Camden County Planning Board Agenda for November 26th, 2019

Review List for Meeting

**CAMDEN COUNTY PLANNING BOARD
COUNTY ENGINEER'S REVIEW
OF SUBDIVISIONS AND
SITE DEVELOPMENT PLANS**

**COUNTY PLAN:
SP-28-2-19/
M-28-1-19**

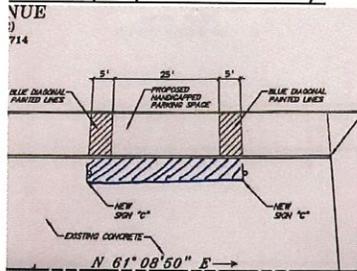
- 3.3 **Site Plan** – the existing site plan must be updated to accurately represent the site. Currently, along Raritan Ave. Cr. 713 there are two driveways that will be closed off and consolidated into one driveway. The two driveways seem to be makeshift and not permitted by the Camden County Permits Department. The Site Plan depicts that the site has existing concrete curb. The curb is severely dilapidated, destroyed and out of place from the use of the unpermitted driveways. The applicant must provide curbing along the entire frontage of the site on Raritan Ave. Cr. 713 and provide the proper County Curb, Roadway restoration and driveway details and required by the Camden County Development Standards.

The site plan must include and depict the centerline of each County Road on the plan.
